RE: Bruce Mondo Jr.
1603 Monroe Turnpike

The following represents our response to your review comments of the above referenced application dated 01/20/2026. **Our response is in bold text.** No revisions will be made to the plans until the new survey and wetlands flagging is obtained.

The following represents our response to your review comments of the above referenced application dated 01/20/2026. **Our response is in bold text.** No revisions will be made to the plans until the new survey and wetlands flagging is obtained.

Stormwater Management System Inspection & Maintenance Manual

Inspection & Maintenance Plan

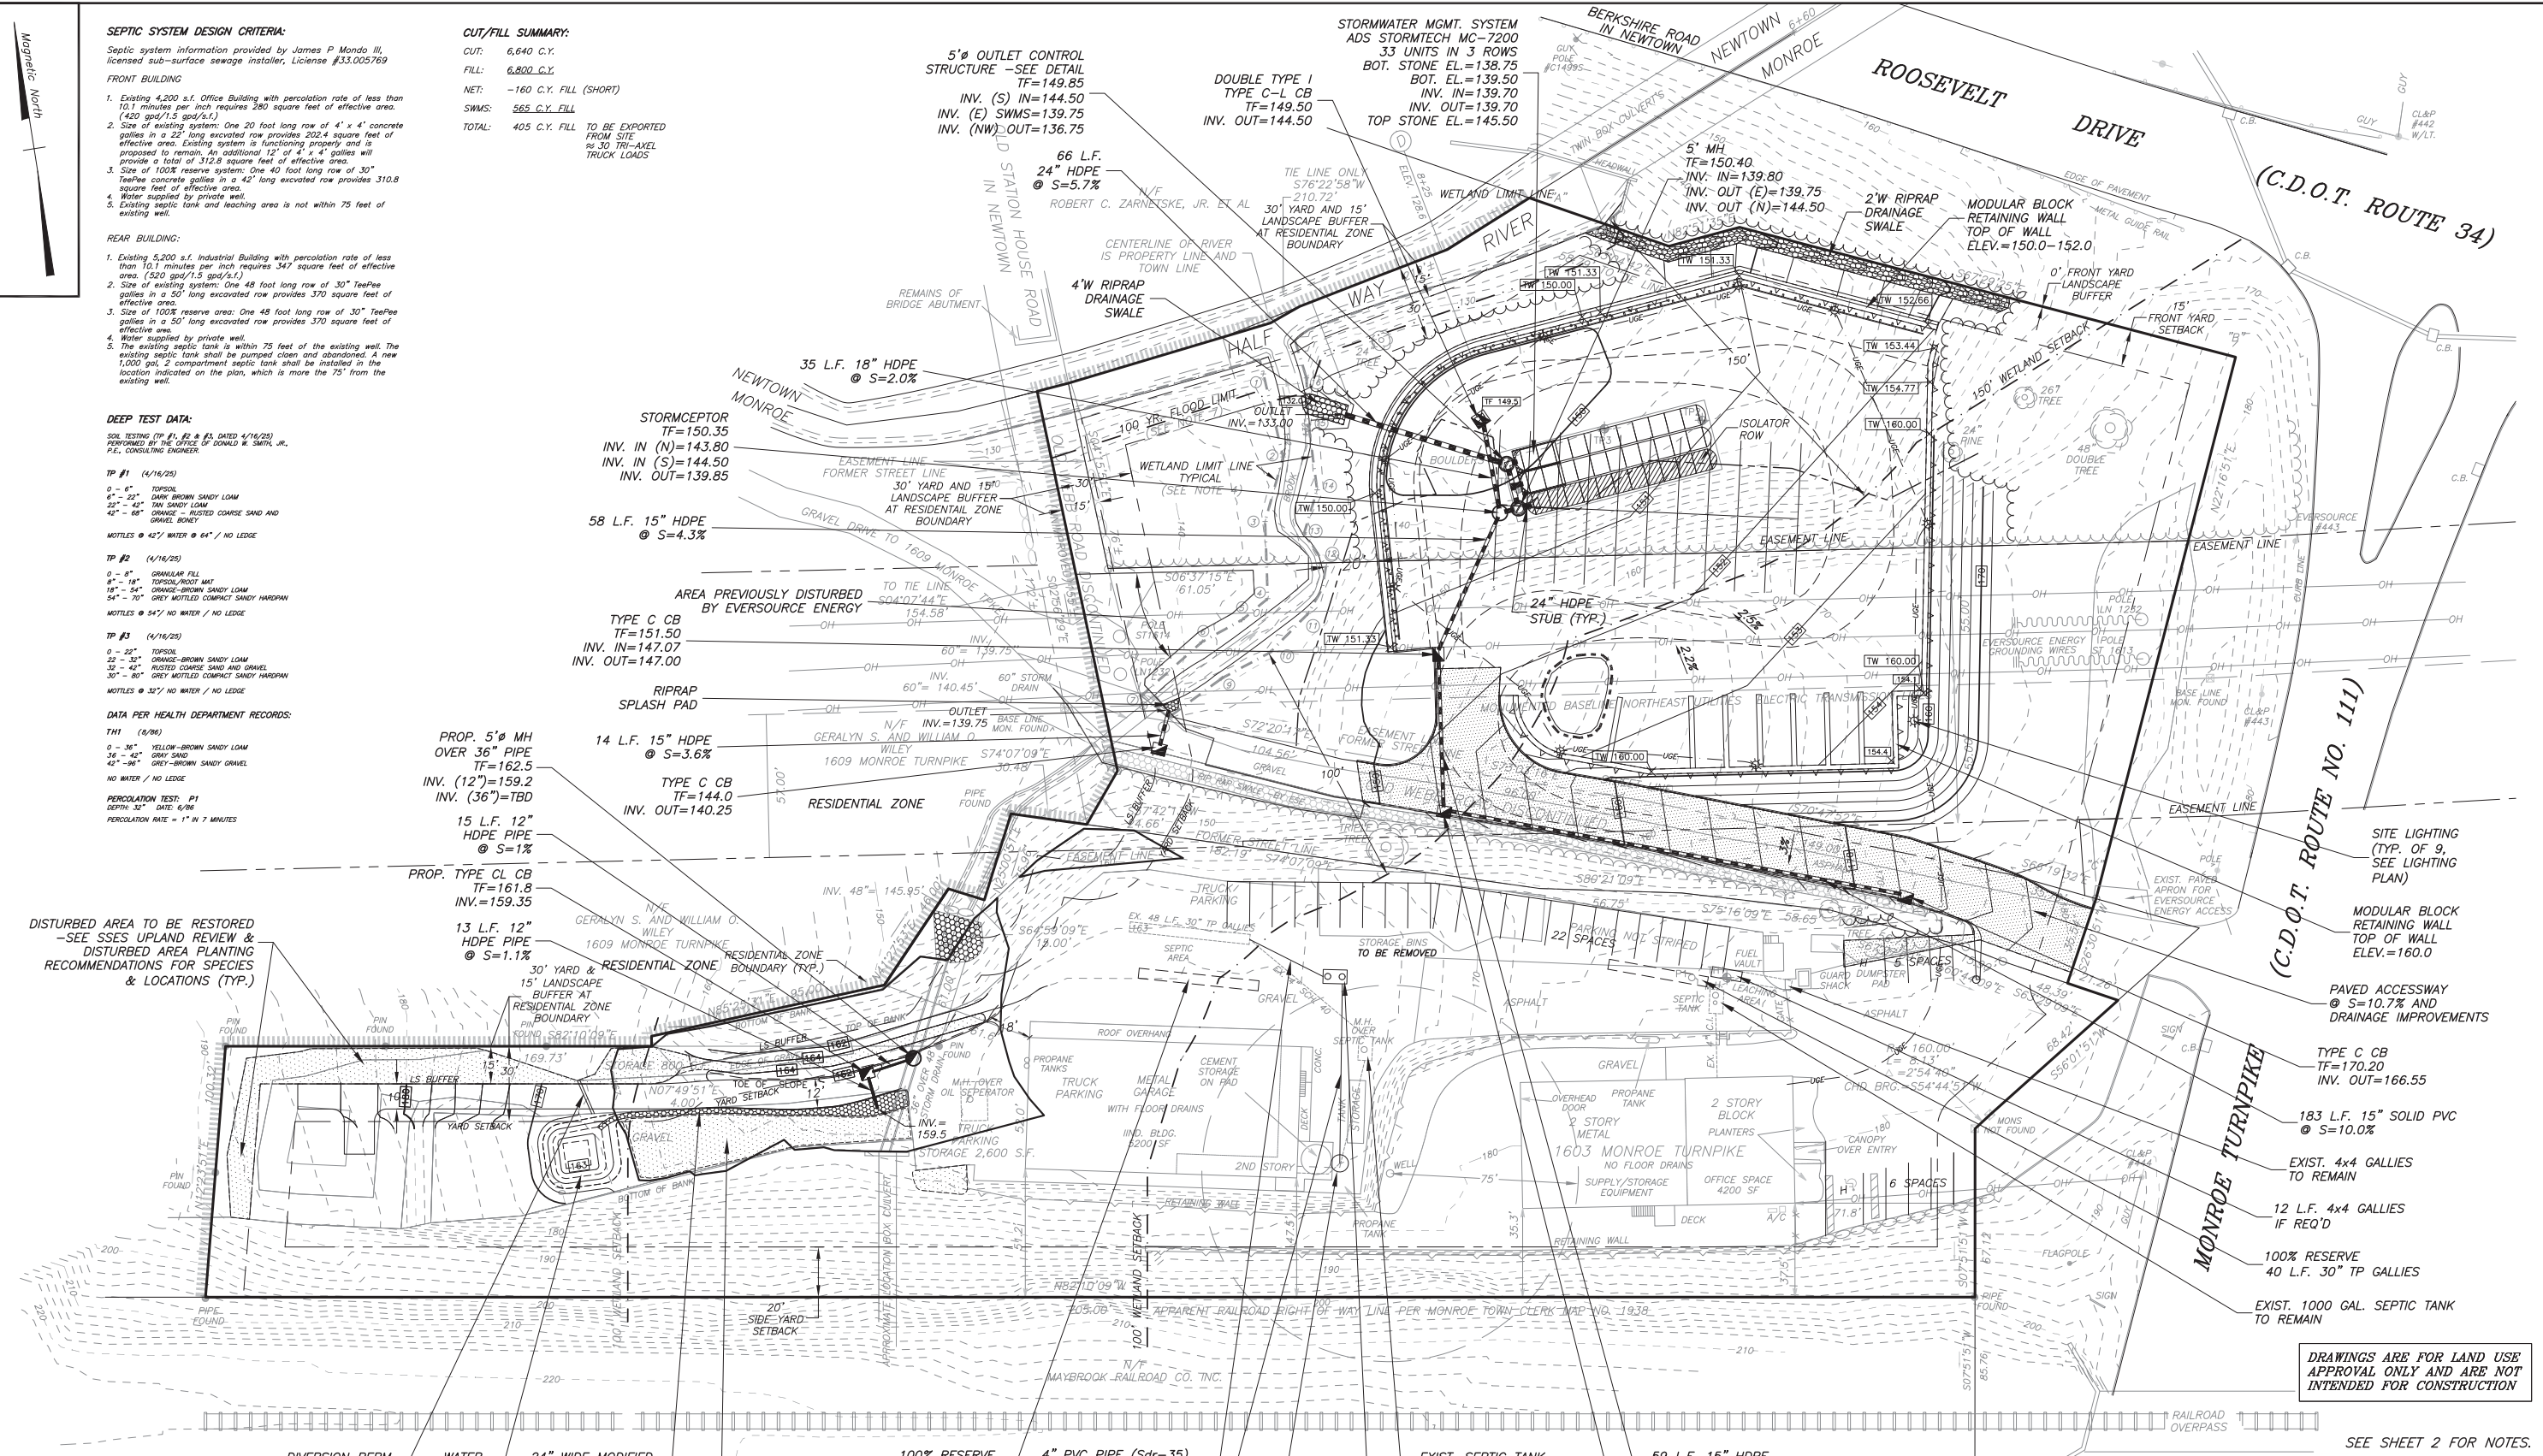
1. Are there any test pits **NO** or any sizing information for the proposed water quality basin? **YES – SIZING INFO ADDED TO SHEET 4** will this basin retain water? **YES, FOR A SHORT DURATION** Will it infiltrate dry? **YES**

2. Provide sizing information for CS-4 units. Include the CFS of water entering the unit to confirm treatment flow (1.3" storm). **SEE ATTACHED**
3. Are you claiming the WQV with infiltration of the underground system or WQF with the CS-4 Unit. If the Water quality is being achieved with the infiltration system the bottom of the system needs to be 3' above ground water/mottling meaning the current system is too low. If WQV bottom of system needs to be 141.2 and need to prove that the system will in fact retain and infiltrate this volume, right now it the outlet pipe for this system is below the required volume storage. If WQF then indicate in report and provide requested info in B.2. **THE CS-4 IS SIZED FOR WQF, THEREFORE INFILTRATION OF THE WQV DOES NOT NEED TO BE 3' ABOVE GW. SYSTEM REMAINS AS DESIGNED.**

4. Provide detail of proposed rip rap drainage swale. **DETAIL WILL BE ADDED TO SHEET 7**
5. Provide stormwater maintenance plan. **SEE ATTACHED.**
